Form 3160-5
(June 2019)

SUNDRY NOTICES AND REPORTS ON WELLS
Do not use this form for proposals to drill or to re-enter an abandoned well. Use Form 3160-3 (APD) for such proposals.

Antietam 9 Fed Com 302H (FKA 212H) API #: 30-025-52253

EOG respectfully requests an amendment to our approved APD for this well to reflect the following changes:

Revised Wellbore A:
 API: 30-025-52253

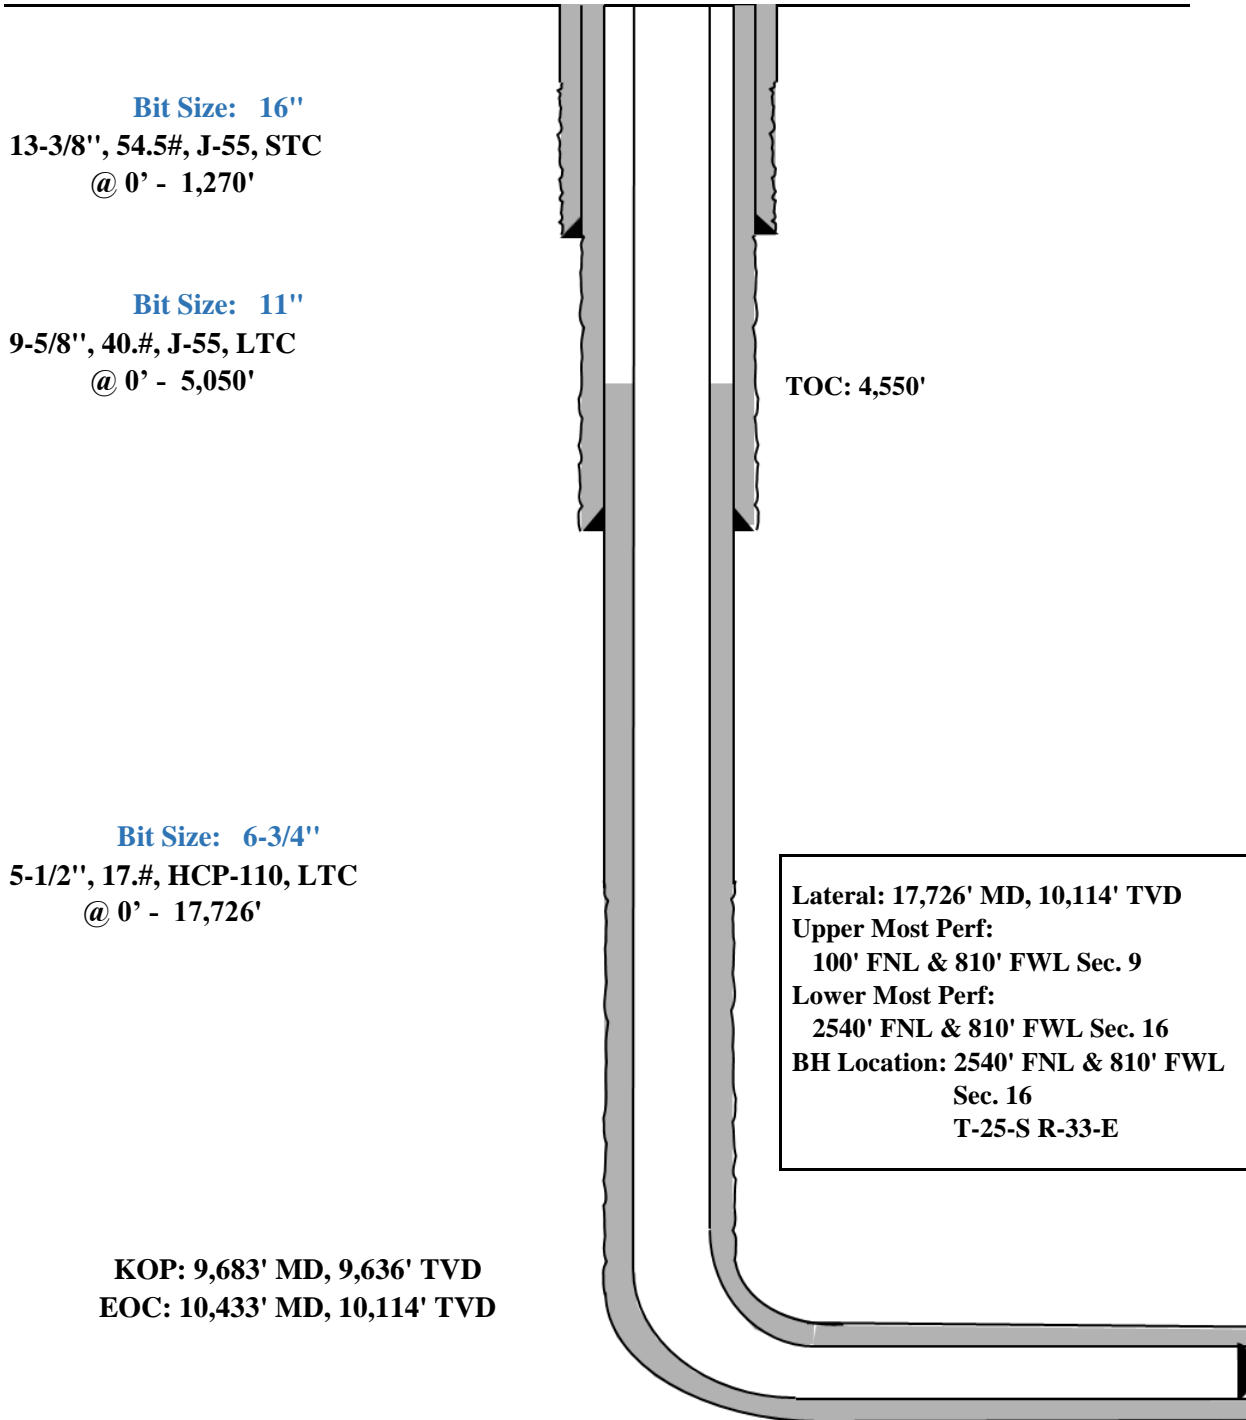
Update casing and cement program to current design.

Casing Program A:

Hole Size	Interval MD		Interval TVD		Csg OD	Weight	Grade	Conn
	From (ft)	To (ft)	From (ft)	To (ft)				
16"	0	1,270	0	1,270	13-3/8"	54.5#	J-55	STC
11"	0	5,096	0	5,050	9-5/8"	40#	J-55	LTC
6-3/4"	0	17,726	0	10,114	5-1/2"	17#	HCP-110	LTC
